IN THE DRAWINGS

REPLACEMENT SHEETS

FIG. 6

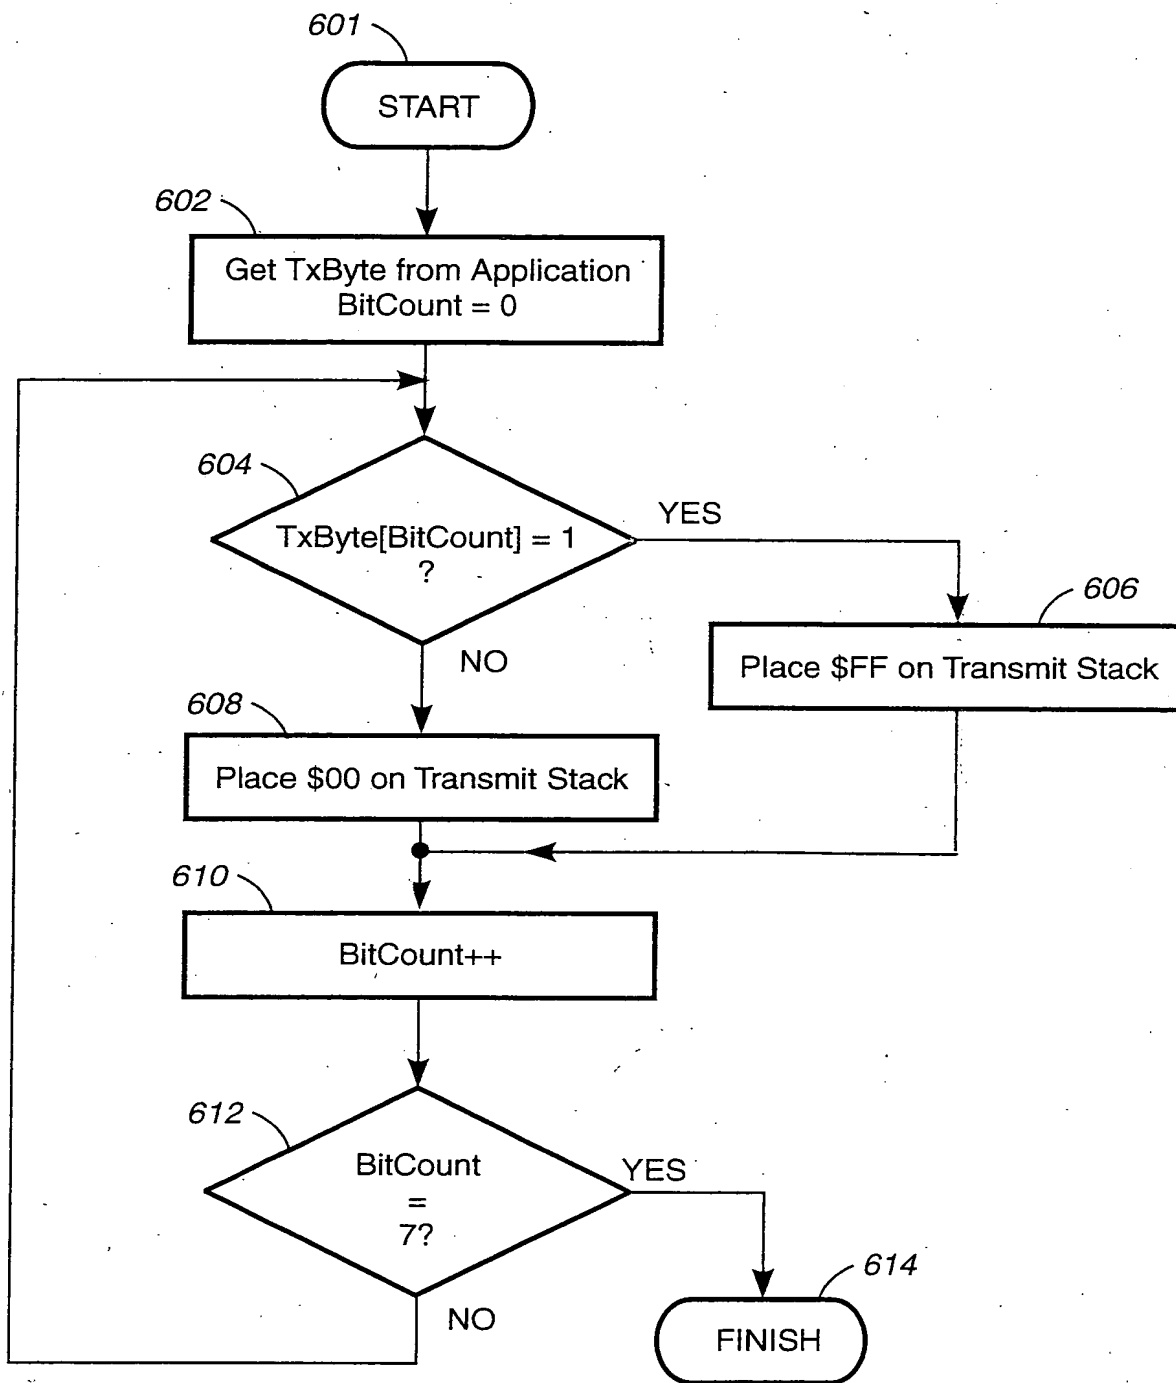
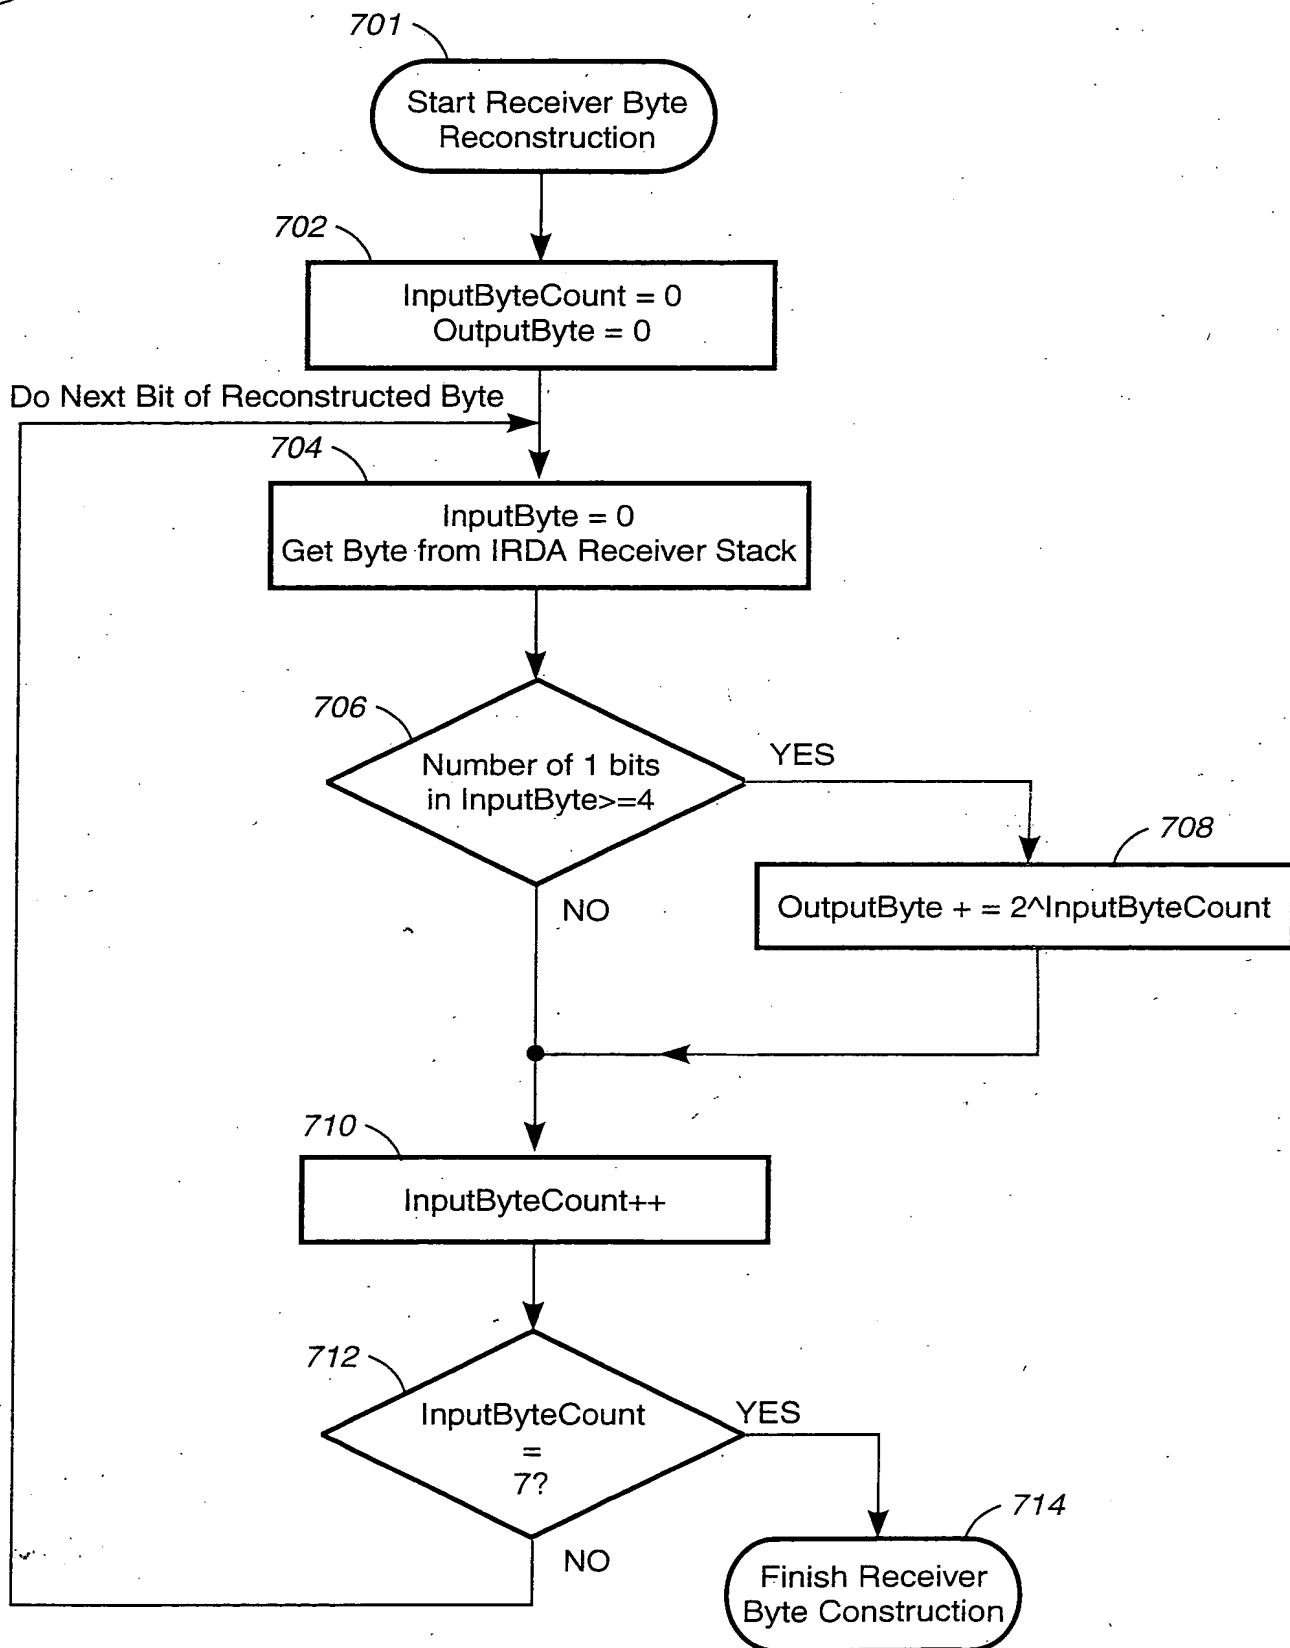
The Examiner's permission is requested to make the following changes to FIGs. 6 and 7 shown in red in the enclosed sketch. Step 606 in FIG. 6, the arrows from decision block 604 to block 606 have been changed to denote the correct flow. Similarly in FIG. 7, the arrow from decision block 706 to block 708 have been changed to correctly denote flow. No new matter has been added. As required under 37 CFR 1.84 an "Annotated Sheet Showing Changes" and a "Replacement Sheet" for FIGs 6 and 7 are attached hereto.
